MEMORANDUM

**RE:** September 21, 2016 - MEETING ISSUE REVIEW

**CSCC #16-03 ;** Consideration of a request to remove unwanted material; replanting of trees, shrubs, grasses and wildflowers within an Upland & Lowland Conservancy District on property known as 4268 Golf Lane (Lot #2 Ponds of Skycrest Subdivision) submitted by Mr. Ronald P Sorce.

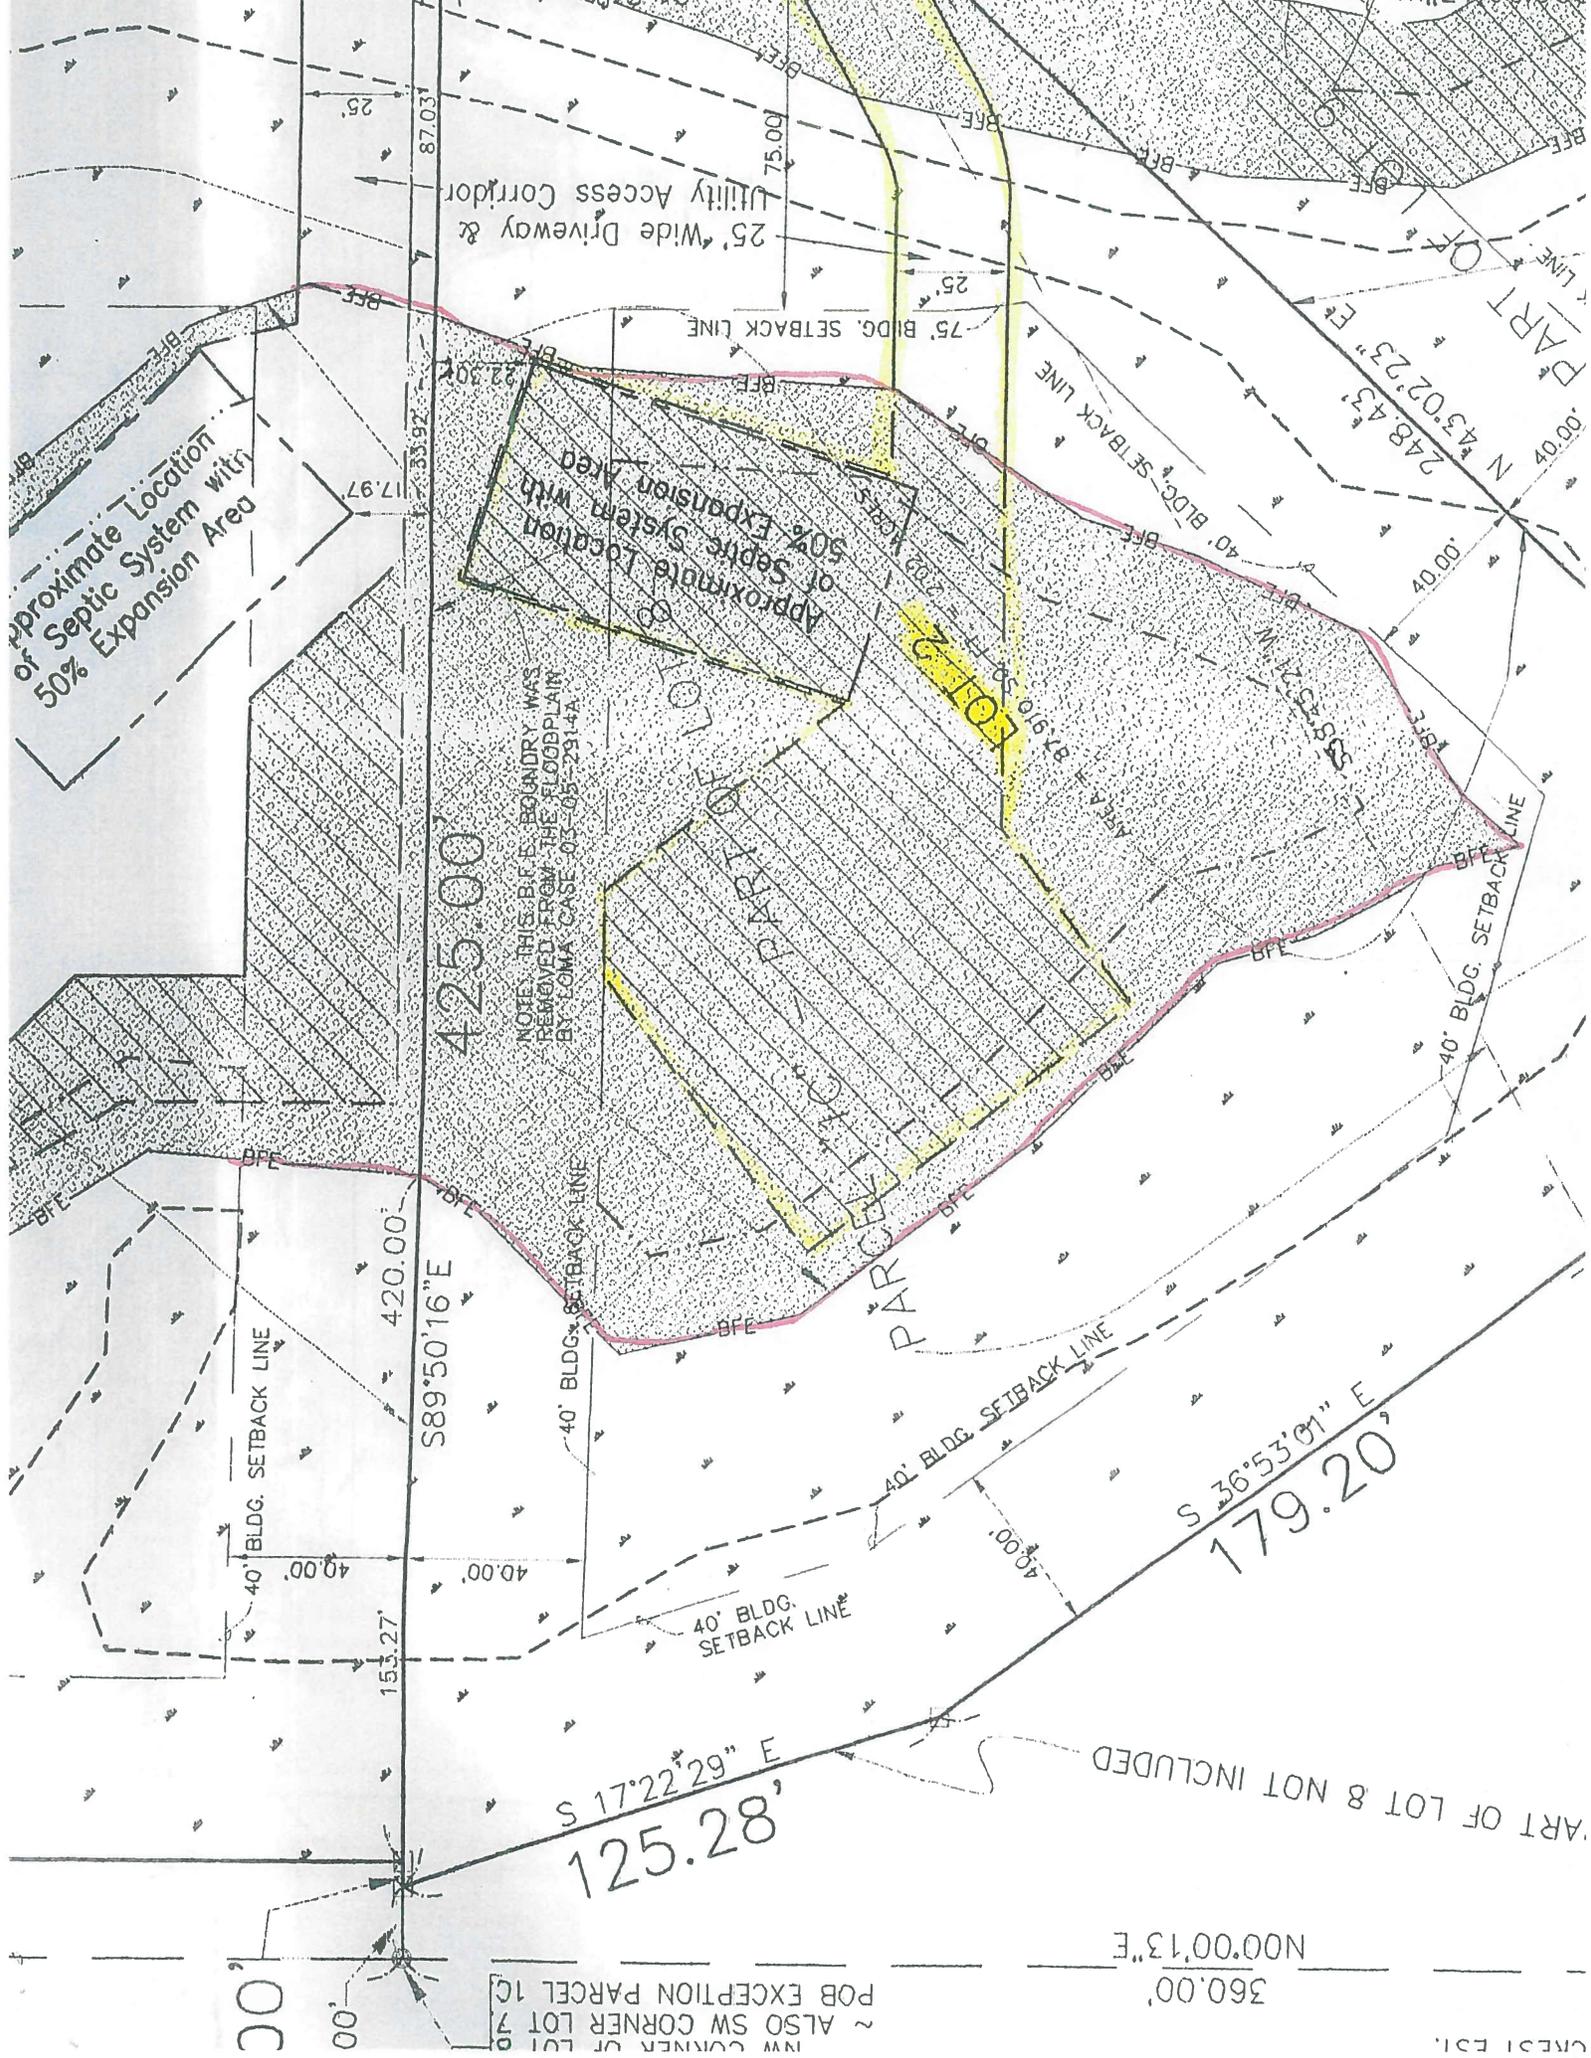
This limitation has been previously granted (in 2005) on this lot. The boundary line between the two types of conservancy district is the Base Flood Elevation (identified as "BFE" ) on the submitted plans. The upland conservancy is on the inside of the BFE line the lowland conservancy is on the outside of the BFE line.

Removal of the materials indicated is a maintenance function and does not require CSCC review and approval. Restoration of the area "disturbed" by the maintenance in the conservancy easement is proposed with a mix of trees, shrubs and plants. Fourteen (14) plant species are proposed for the restoration as well as a deer resistant short prairie seed mix. Of these seven (7) do not appear to be on the "Approved Species List". The seed mix\restoration should be reviewed and approved by the CSCC. Kelley is primary; Sharon is secondary.
